The Town of Hilton Head Island Regular Design Review Board Meeting

The Town of Hilton Head Island
DESIGN REVIEW BOARD
Minutes of the Tuesday, November 23, 2010 Meeting **DRAFT**
1:15pm – Benjamin M. Racusin Council Chambers

DESIGN TEAM/ DRB COMMENT SHEET

FIRST PRESBYTERIAN CHURCH PHASE II – MODIFICATIONS & ADDITIONS

ONE HOT MAMA'S AWNING

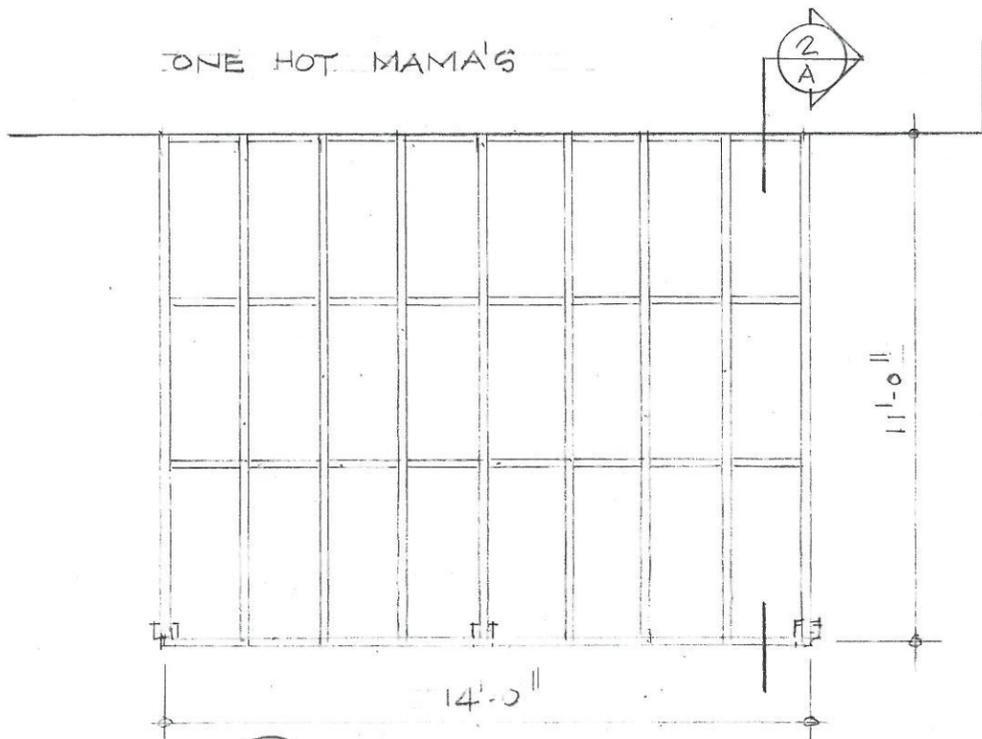
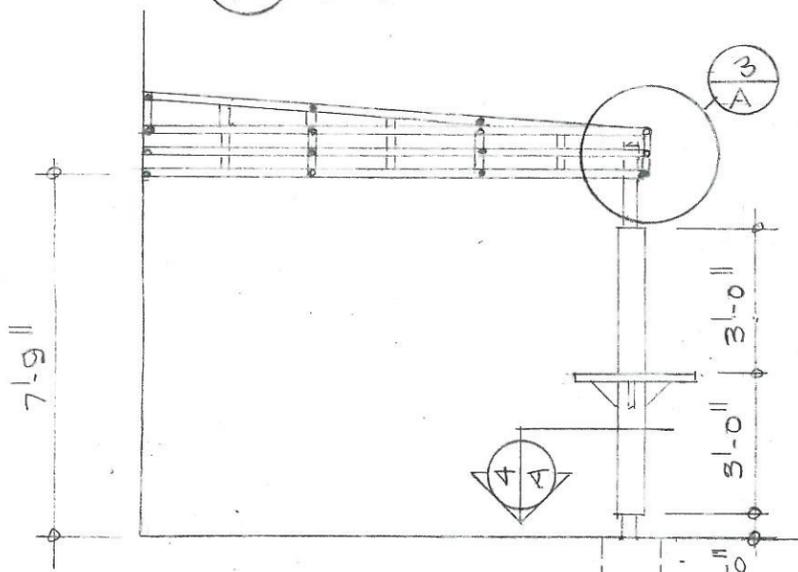
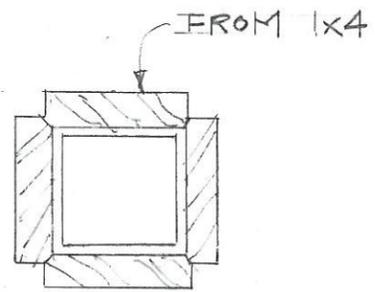
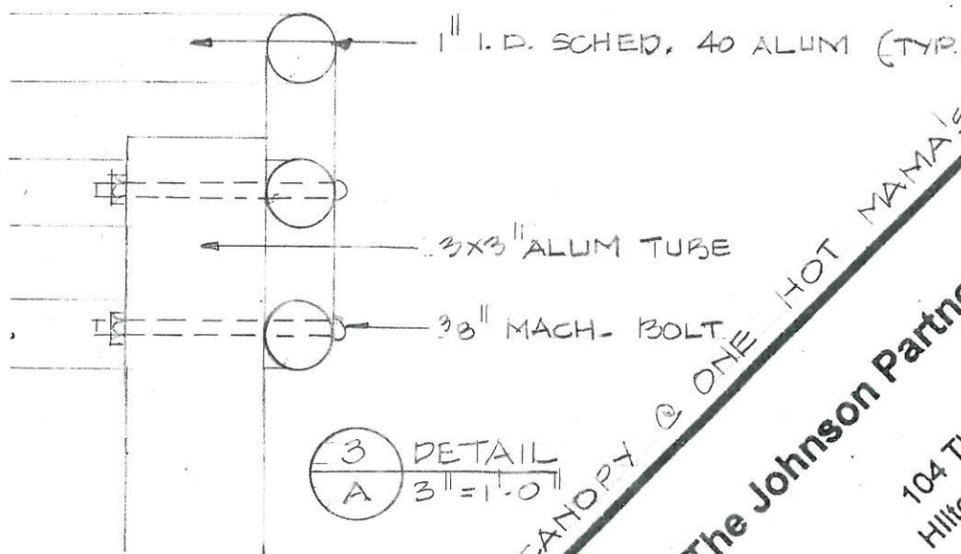
ARCHITECTURAL DESIGN		
A replacement of a previously existing awning over the outdoor bar- Applicant will need to verify how and where the awning resolves into the wall and connecting parapet feature in the courtyard		
DESIGN GUIDE/LMO CRITERIA	COMPLIES YES/NO/N/A	COMMENTS OR CONDITIONS
Structure is designed to be appropriate to the neighborhood		
Promotes pedestrian scale and circulation		
Design is unobtrusive and set into the natural environment		
Utilizes natural materials and colors		
Avoids distinctive vernacular styles		
Design is appropriate for its use		
All facades are have equal design characteristics		
Avoids monotonous planes or unrelieved repetition		
Has a strong roof form with enough variety to provide visual interest		
Minimum roof pitch of 6/12		
Overhangs are sufficient for the façade height.		
Forms an details are sufficient to reduce the mass of the structure		
Human scale is achieved by the use of proper proportions and architectural elements

DATE
November 30, 2010
PROJECT NUMBER
01-10014
SHEET TITLE
SITE PLAN
& DETAILS

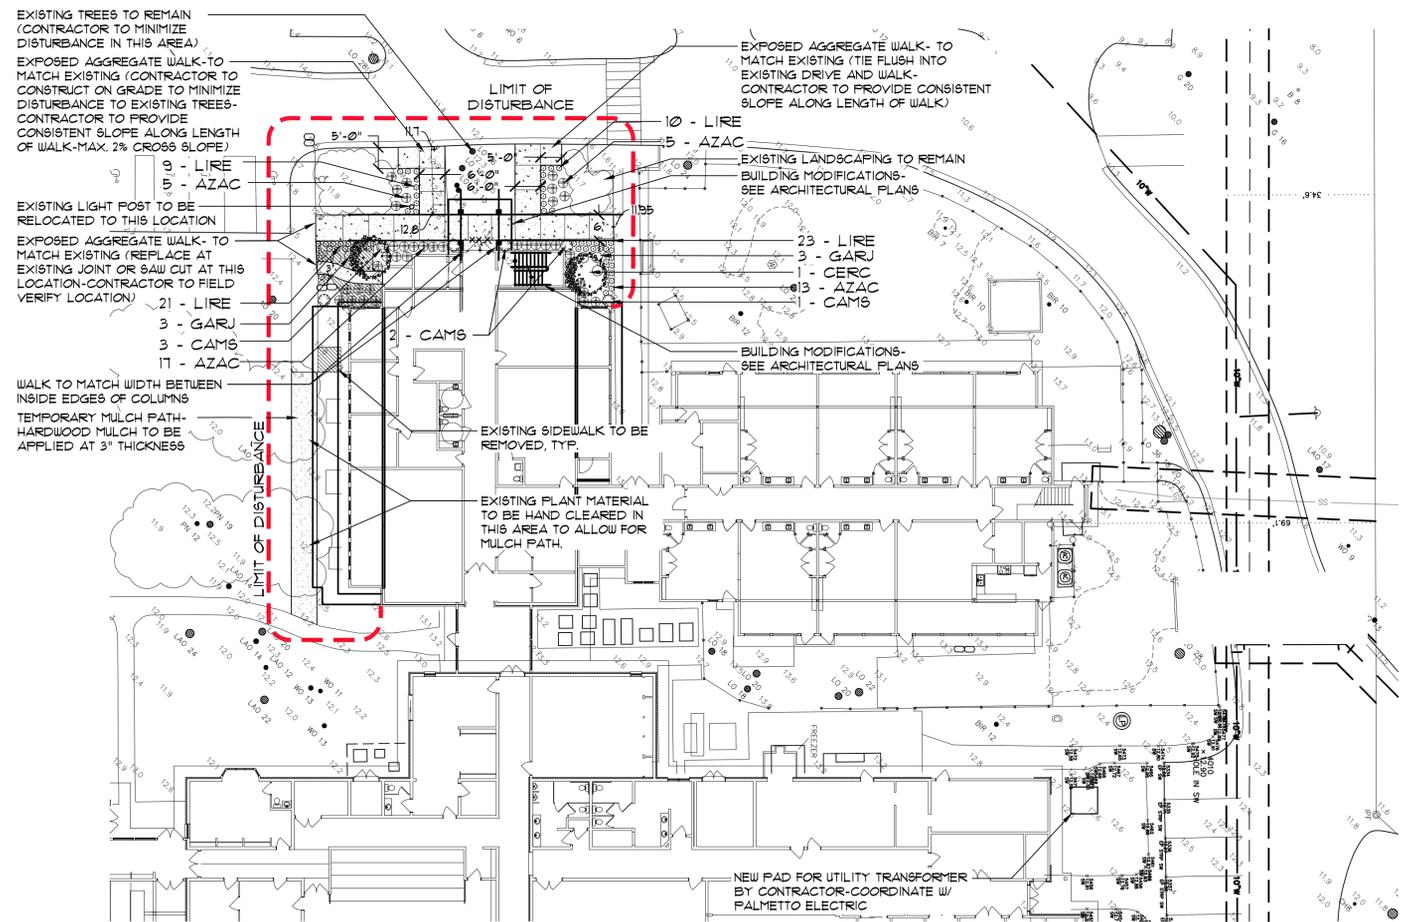
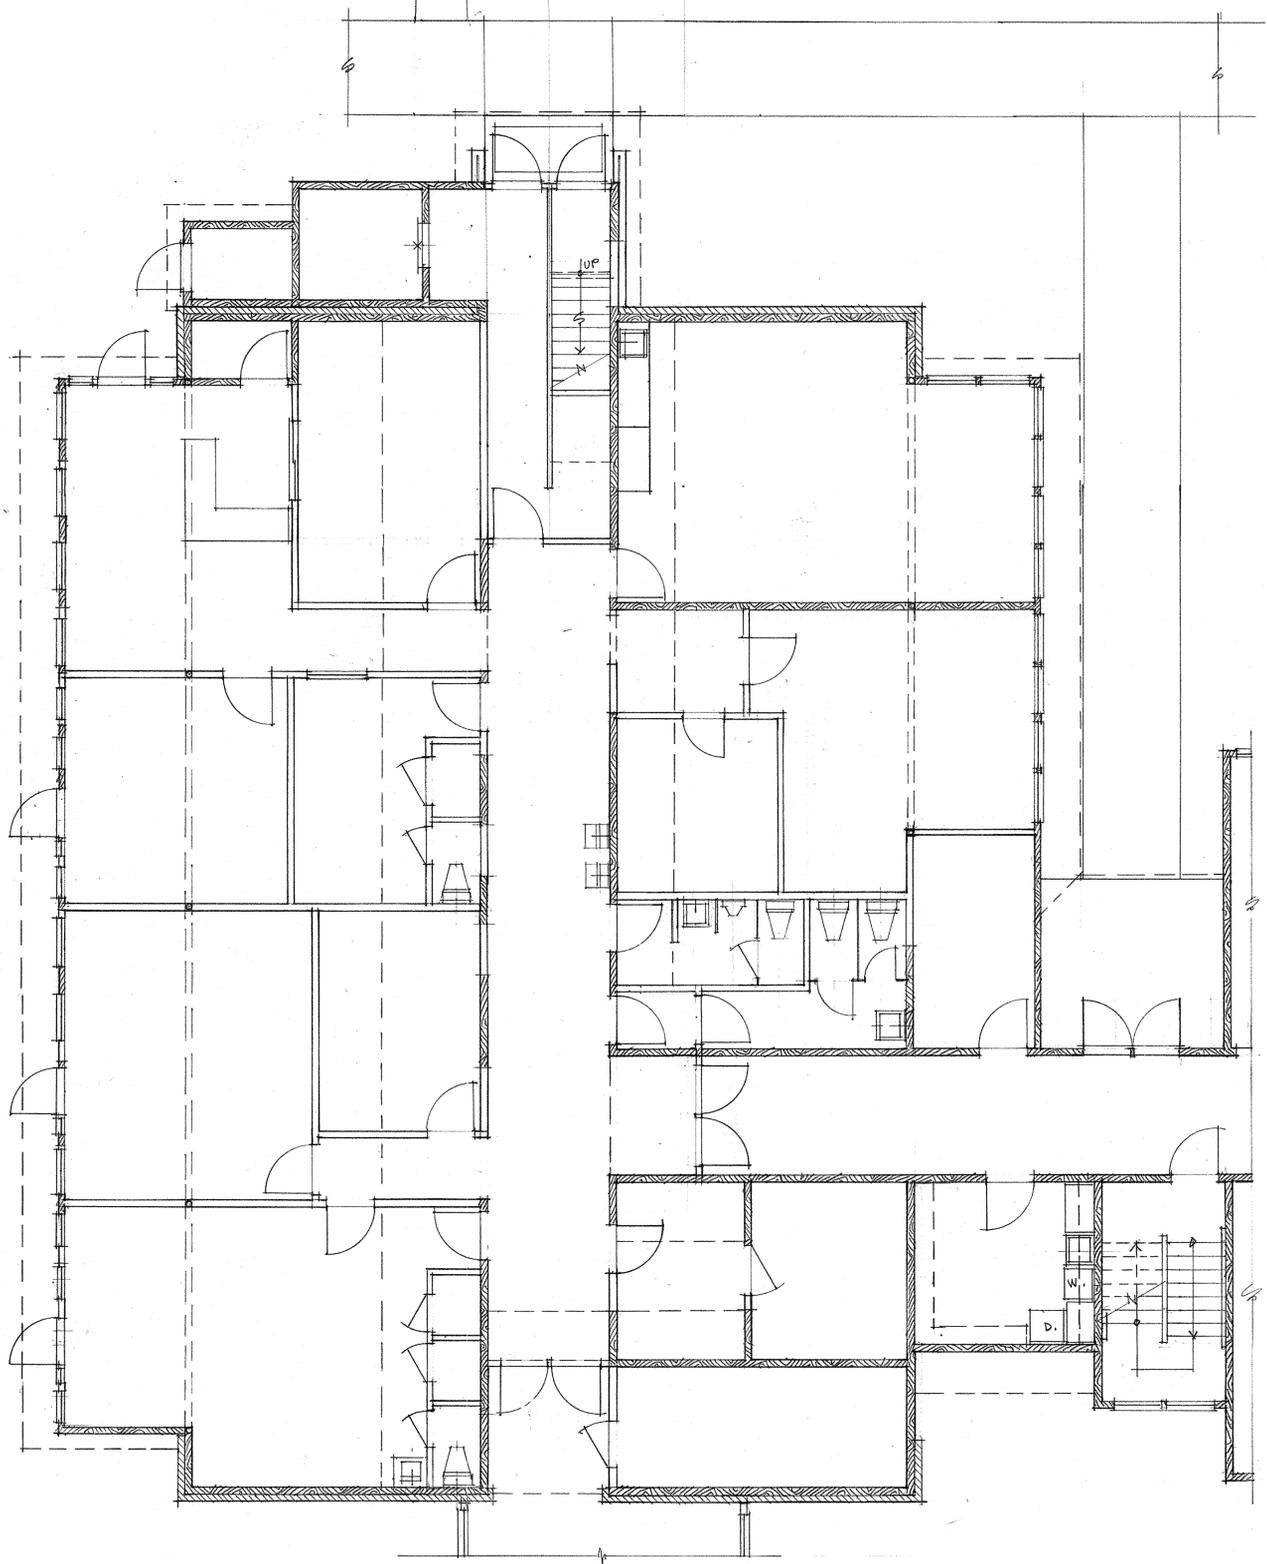
Existing trees take added importance in softening the new, large Pattern 139 addition for the stairwell, and they also constrain the ability to increase the bed size in front of this wall, given the new covered entry configuration. Every attempt should be made to minimize the impact on the existing trees and landscaping, as noted. The size and placement of the proposed azaleas and redbud anchoring the corner should be carefully considered as well.

DESIGN GUIDE/LMO CRITERIA	COMPLIES YES/NO/NA	COMMENTS OR CONDITIONS
An effort has been made to preserve existing trees and under story plants		Because of large trees near sidewalks to be replaced, sidewalk must go back in same footprint, or must be on top of existing grade.
Supplemental and replacement trees meet LMO requirements for size, species and number		
Wetlands if present are avoided and the required buffers are maintained		
Sand dunes if present are not disturbed
